**PLAINVIEW PLANNING COMMISSION
MEETING AGENDA**

Date: January 26th, 2021
To: City of Plainview Planning Commission
From: Harry Davis, AICP
Brian Malm, P.E.
Subject: Marshman Addition – Preliminary Plat Application
City of Plainview

Name: Marshman Addition Preliminary Plat Application

MARSHMAN ADDITION
PLAINVIEW, MINNESOTA
PRELIMINARY PLAT

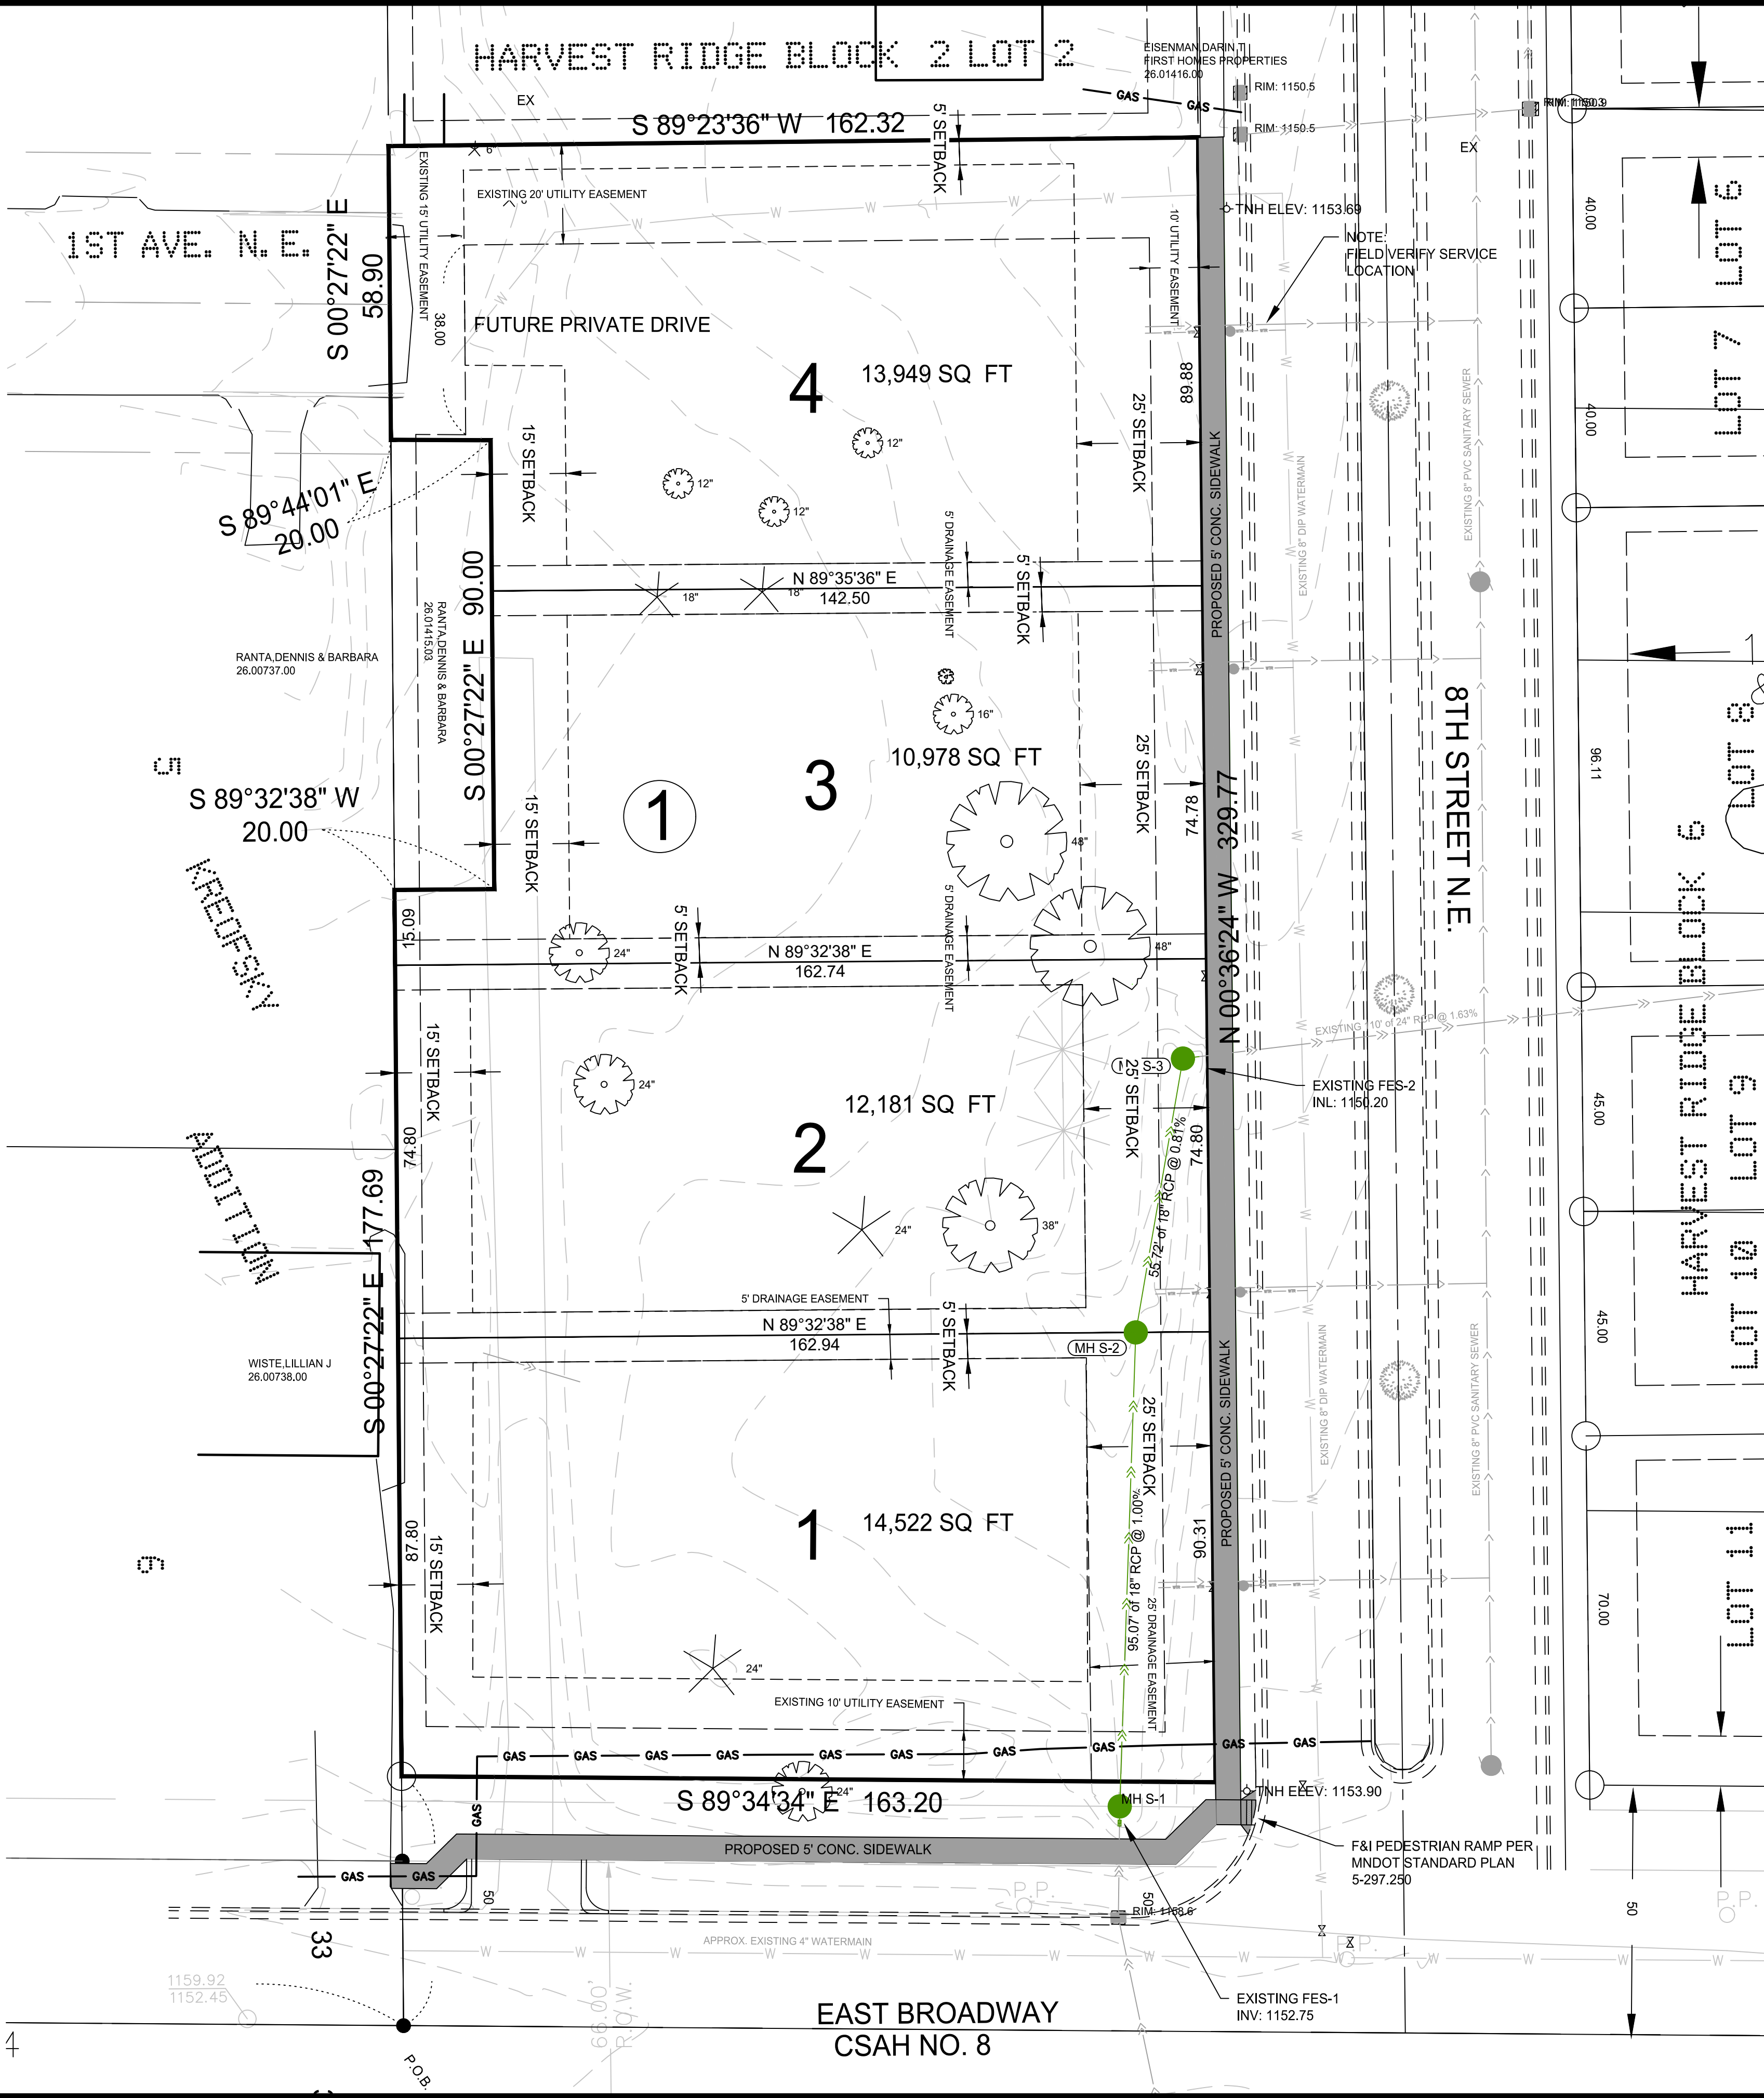
Finding: The lots in the proposed Marshmann Addition generally meet zoning requirements for lot area, frontage, and uses in R-2 zoning, with the exception of setbacks on the corner lot. Corner lots shall have front setbacks along street frontages and all other setbacks shall be side yards. One of the front setbacks shall be half the requirement of a typical setback. This is a requirement for corner lots and front yards under Section 607.

Required Improvements: The applicant is not proposing any new streets, but will need to place sidewalk along all street frontages. Sidewalk width along County Road 8 (East Broadway) shall be 5-feet wide with location as approved by the County. Sidewalk width and location along 8th St. NE shall be 5-feet wide and 6-inches from the edge of right-of-way in conformance with the typical residential street section.

Storm sewer improvements will be required to convey drainage from an existing 21-inch County culvert under County Road 8 (East Broadway) to an existing 24-inch City culvert under 8th Street NE. Inlets may be required to collect drainage from the proposed lots, depending on proposed lot grading, if drainage from lots is not able to flow onto 8th Street NE. The culvert and ditch arrangement as shown on the initial submittal by the applicant would not be acceptable due to ongoing maintenance issues (debris and silt collection issues). A subsequent submittal by the applicant showing an 18-inch storm sewer connection would not be acceptable as it is undersized to accept drainage from the County's 21-inch storm sewer under County Road 8 (East Broadway). A minimum 21-inch RCP storm sewer would be required. If inlets are needed to facilitate lot drainage, hydraulic calculations should be provided to verify pipe sizing is adequate.

Sump pump services should be provided for each lot according to the City standard detail. It does not appear that subdrain was installed as a part of the construction of 8th Street NE. Normally sump pump outlets from each lot are connected to the subdrain pipe. In this case, a 6-inch subdrain outlet pipe, connected to the proposed storm sewer, should be installed to provide an outlet for the sump pump services.

- a) The culvert under County 8 is a 21" RCP (round). Please size the proposed driveway culverts and/or driveway finish surface elevation as necessary for the drainage area and to not influence drainage from County 8. The proposed grading plan indicate two sizes (2) 18" and downstream (2) 12" (this would seem to be in error). If a buried storm sewer is being considered, it is recommended a manhole be constructed at connections to existing culverts and/or directional changes in pipe. Future maintenance or replacement of culverts or drainage structures beyond the extents of the existing culverts maintained by the County would be the sole responsibility of the City.

- b) Property tile lines or sump outlets shall not be cut into curb/gutter line or otherwise flow overland onto street(s).
- c) Driveway slopes are required to be less than 2% in areas with planned sidewalk or (in the case of along County Hwy 8) where future sidewalk may be constructed. This requirement is to enable planned and future construction of sidewalk to meet standards for constructed cross slope. Verify the crossing (ped ramp) it is directly across from the existing ped ramp to the east and with a ped ramp at a directional crossing (not a fan/diagonal design). MnDOT standards are noted but please verify elevations would enable construction of these standards. Future maintenance (including snow removal), replacement, or improvements of sidewalk (additional to existing) within the right of way of County 8 would be the sole responsibility of the City.

3. Prior to City Council review:
 - a. The applicant shall show the correct setbacks on the preliminary plat;
 - b. The applicant shall revise the proposed drainage design to meet City and County requirements for storm sewer and revise the proposed grading plan accordingly.

- c. The applicant shall revise the plan to include the installation of sump pump services to each lot in accordance with City standards.
 - d. The applicant shall comply with County requirements related to sidewalk and pedestrian ramp design for the sidewalk within the County Road 8 (East Broadway) right-of-way.
